REVISION 2	DATE:
REVISION 1 DEVICE ADDS	DATE: 08/11/2014
REVISION 0 SUBMITTAL	DATE: 07/30/2014

FACP WIRING RISER

PROJECT NAME	SCALE NTS
118 ON MUNJOY PORTLAND, ME 04101	BY: JRS
	CK BY:
	SAVED AS:
 Prepared For Tomorrow, Delivered Today 2257 BROADWAY, SOUTH PORTLAND, MAINE

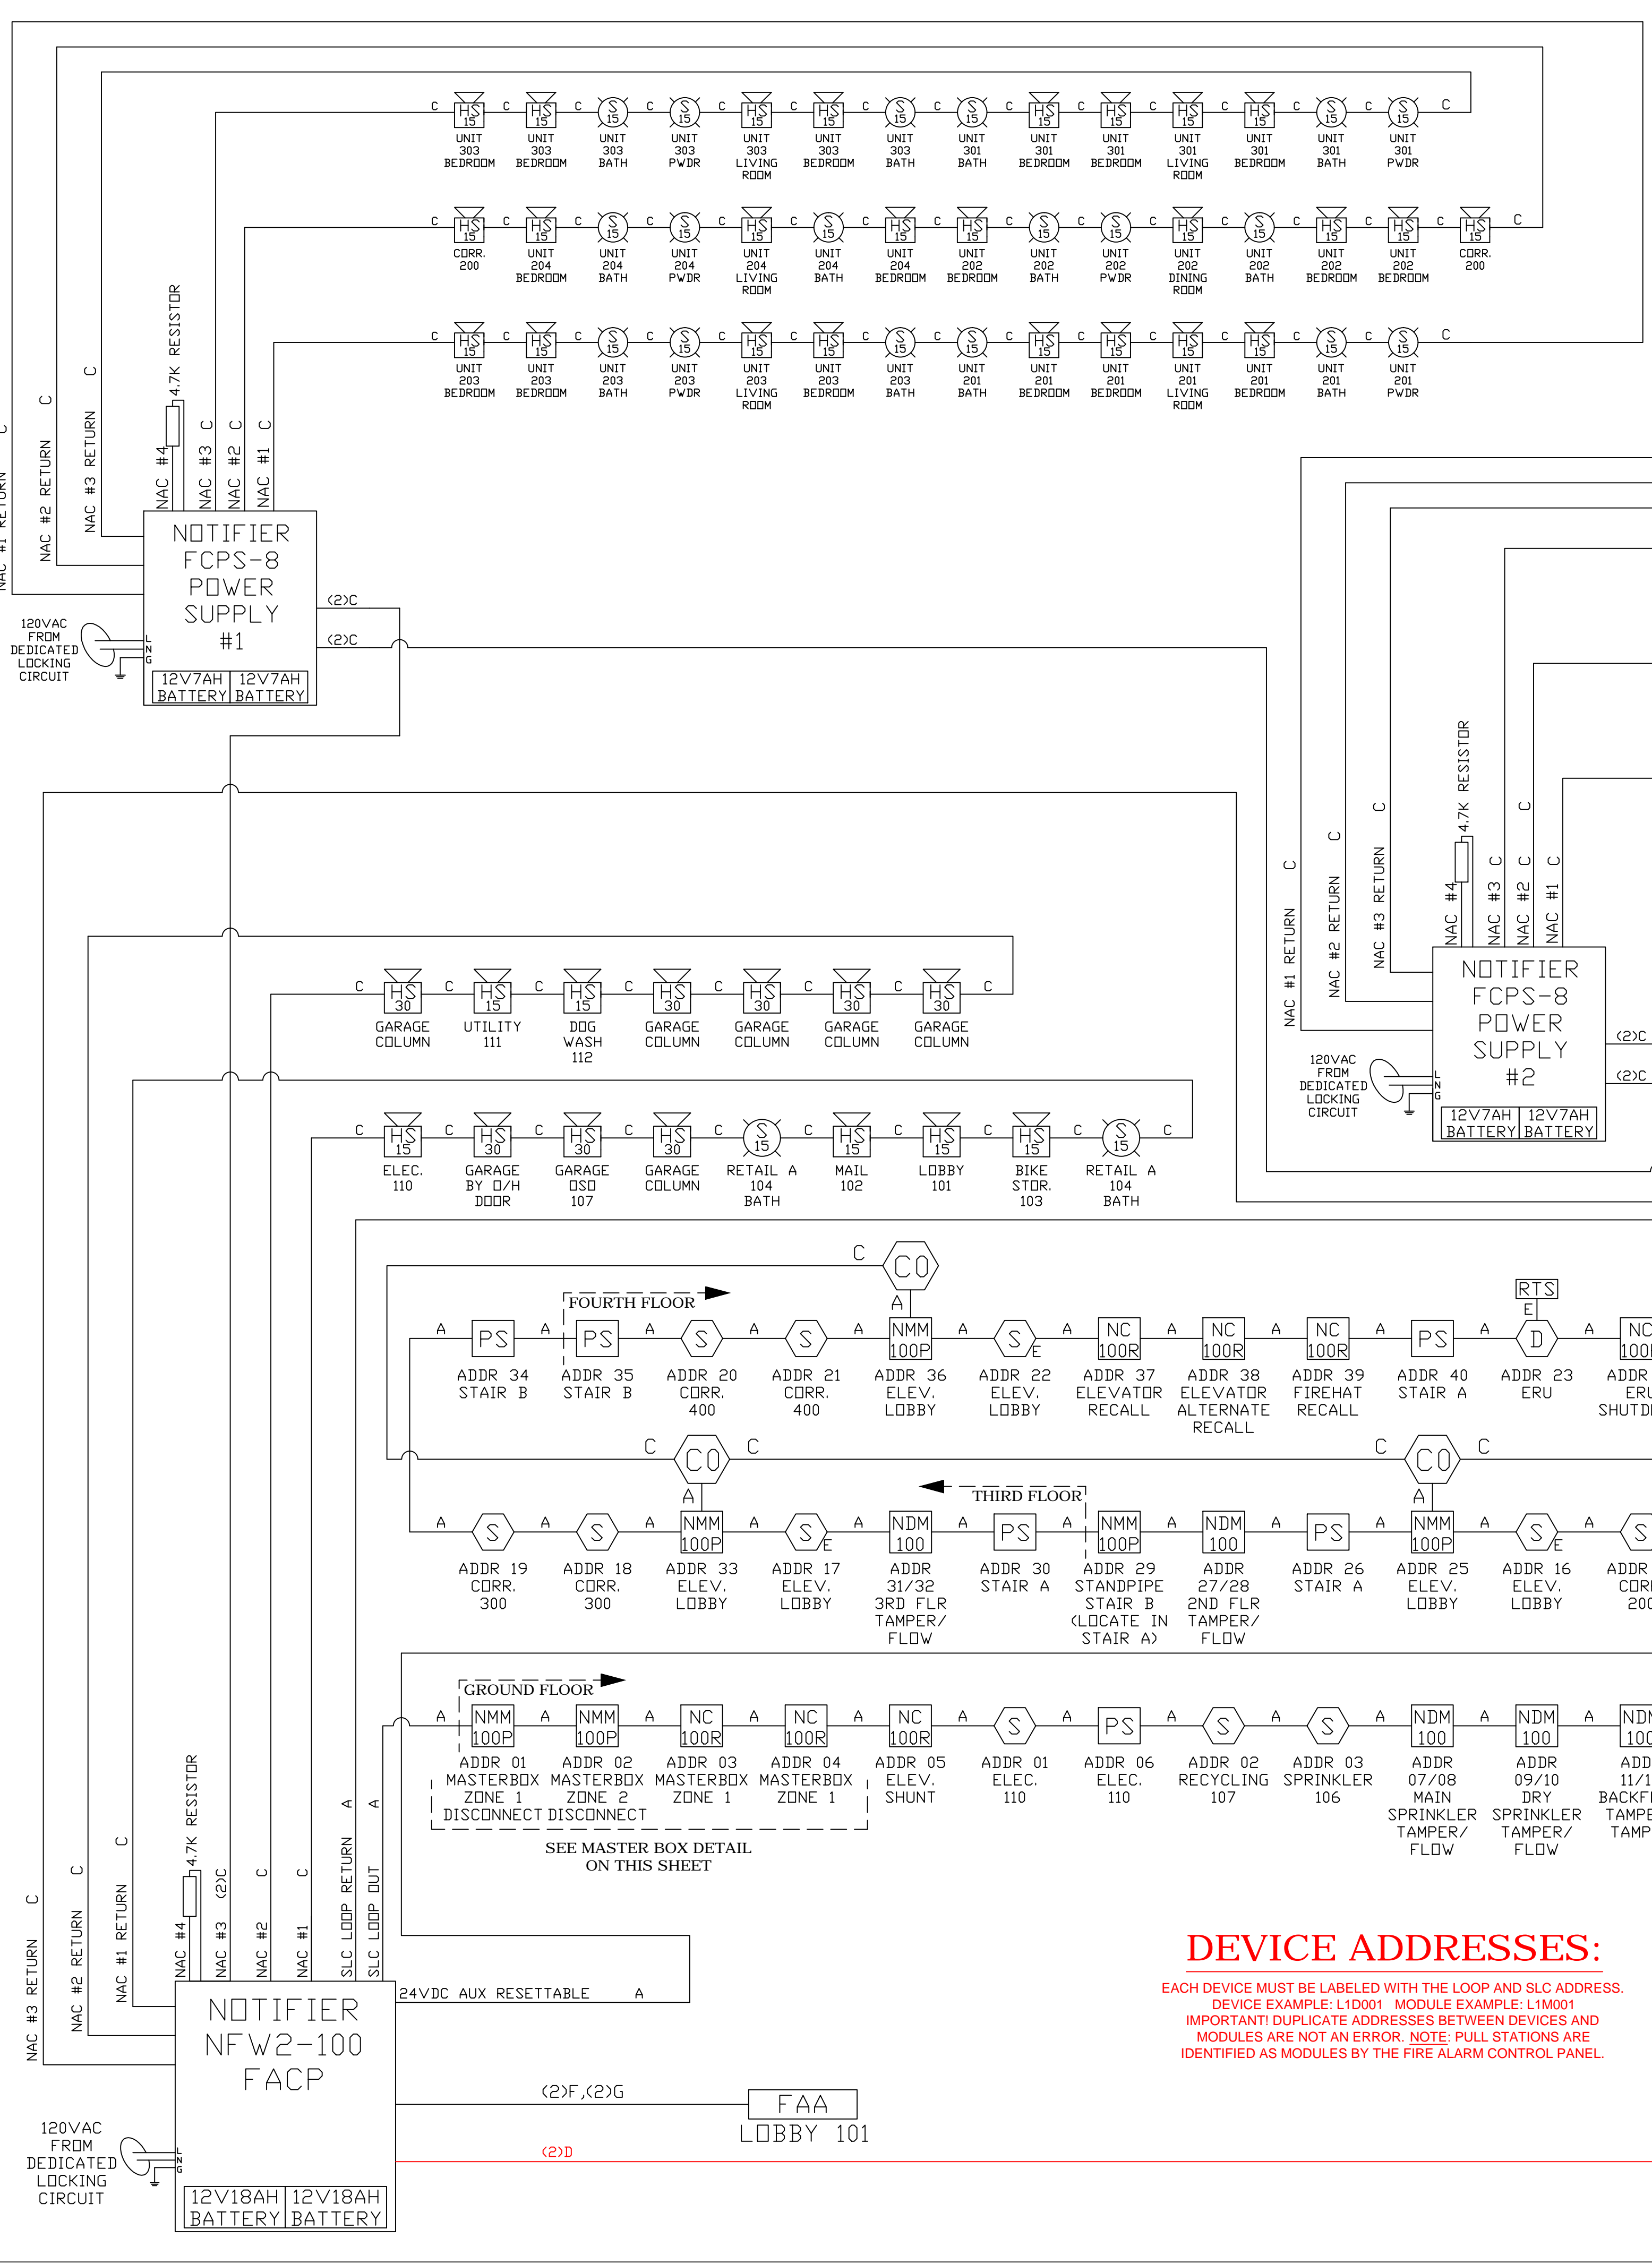
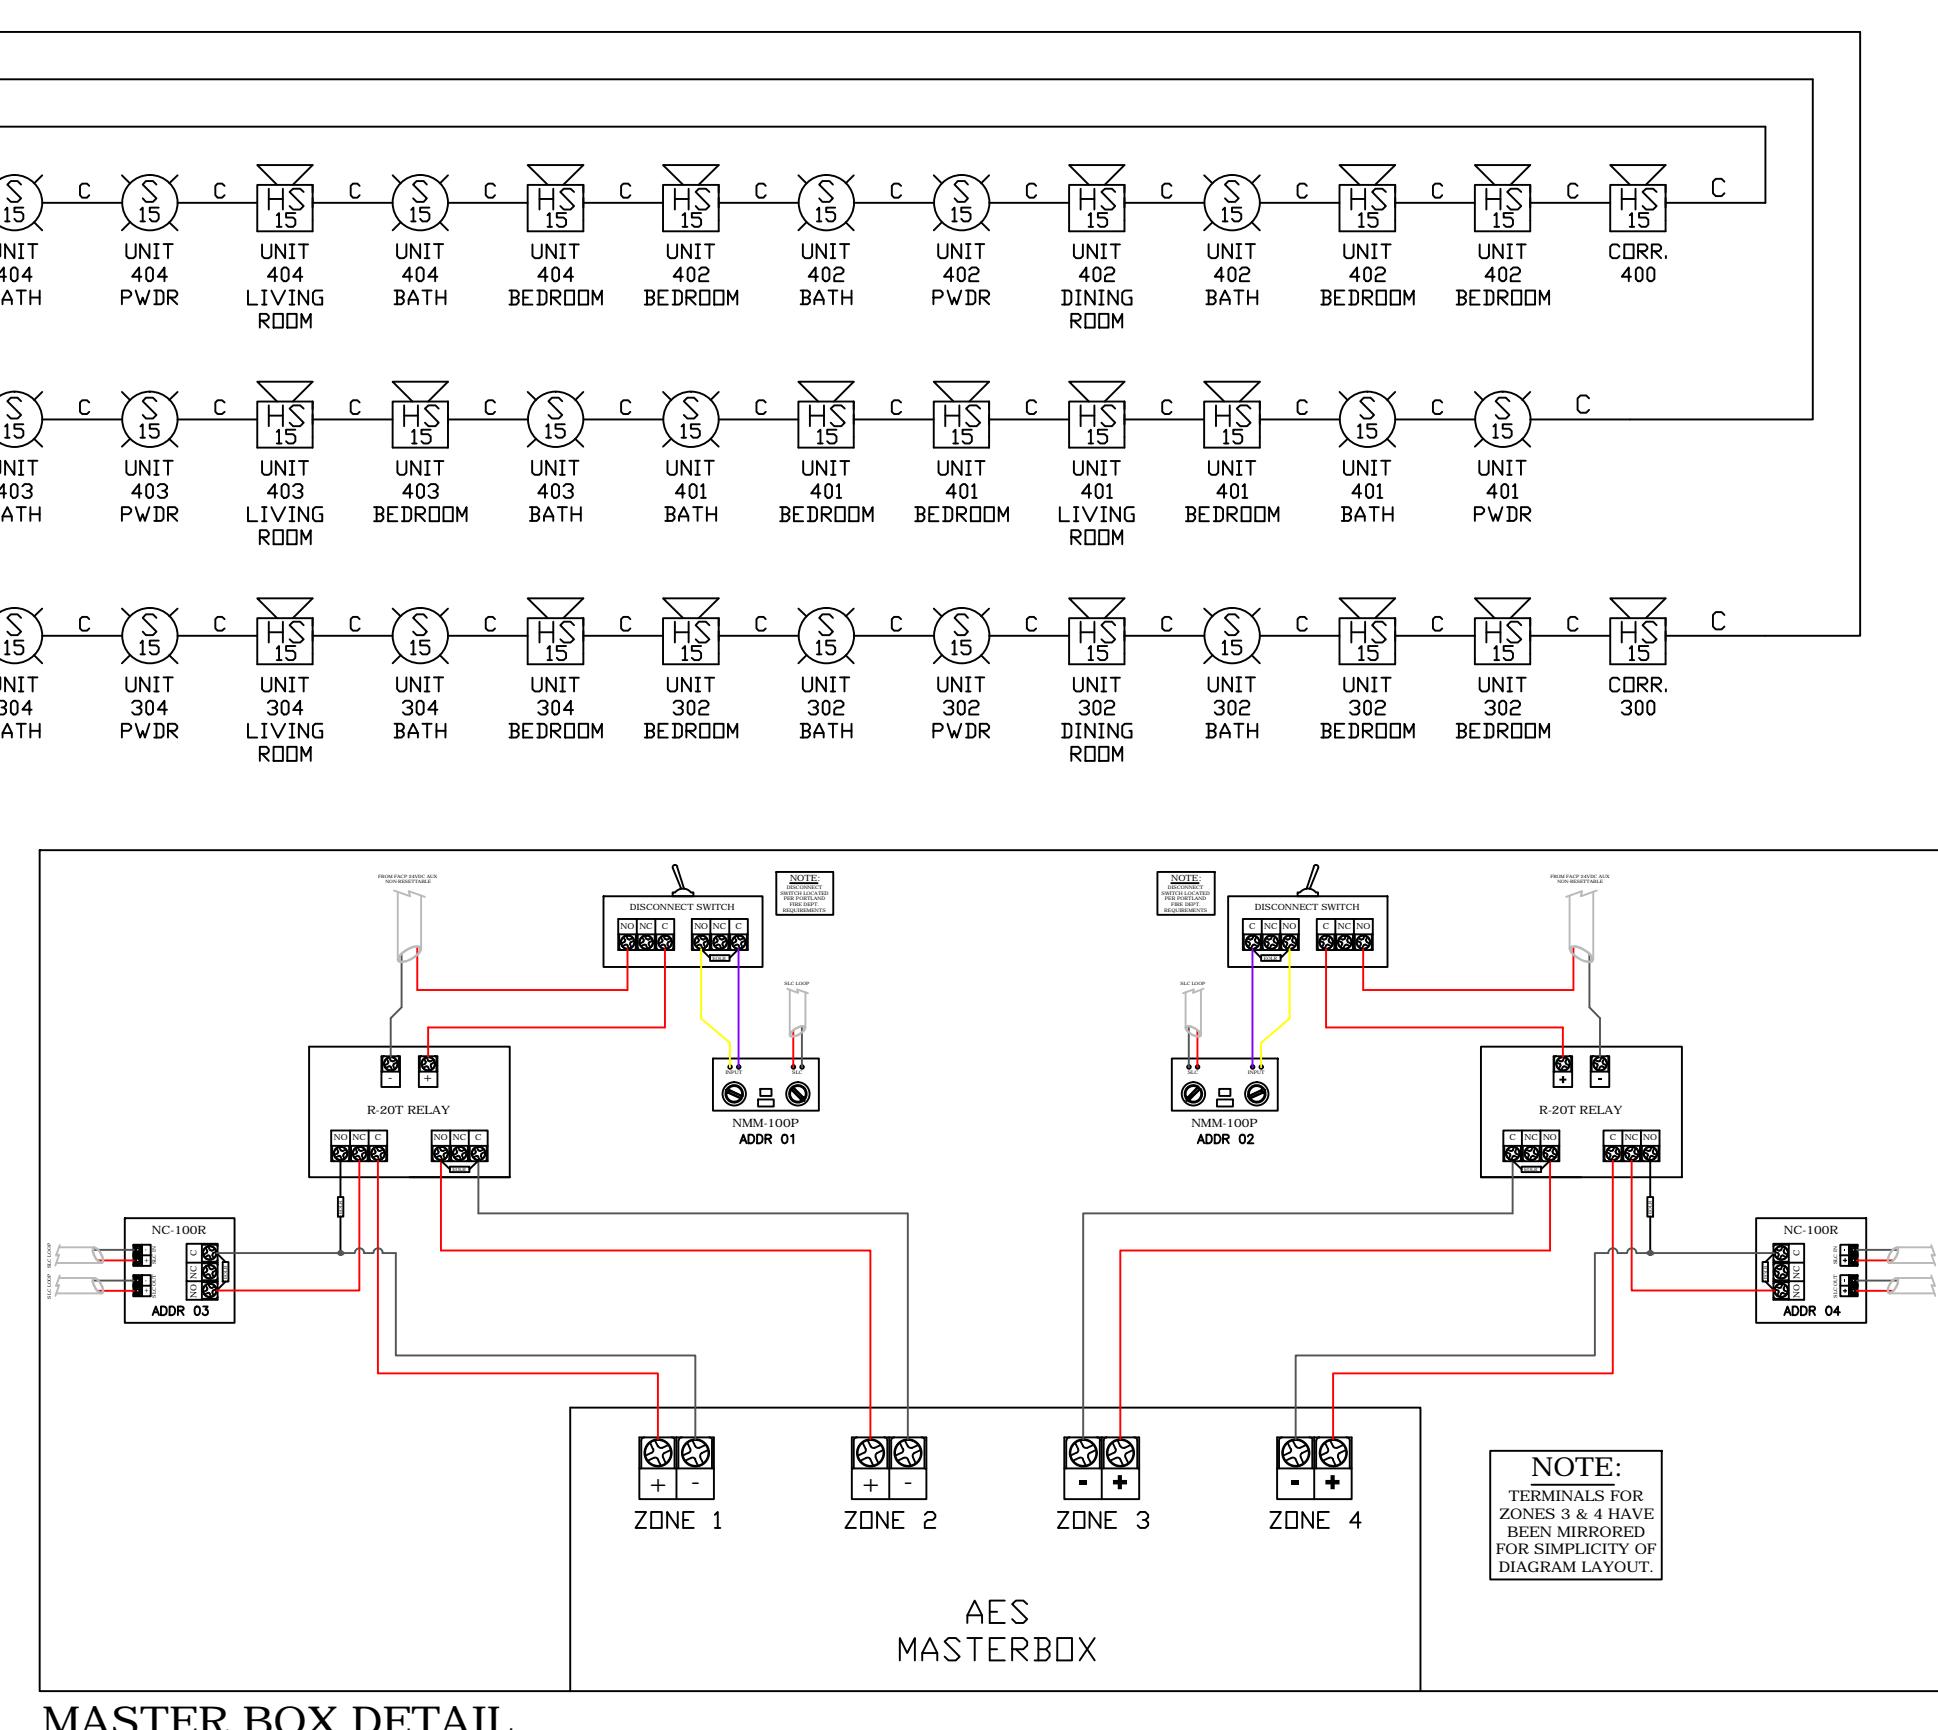
This drawing includes 2 added pull stations one in each retail space by the door. We have added controls for flow and tamper for each level, Flow and tamper for the dry system, low pressure, 2 - bypass valves, and tamper for each standpipe in the stairs per the sprinkler contractors list of devices.
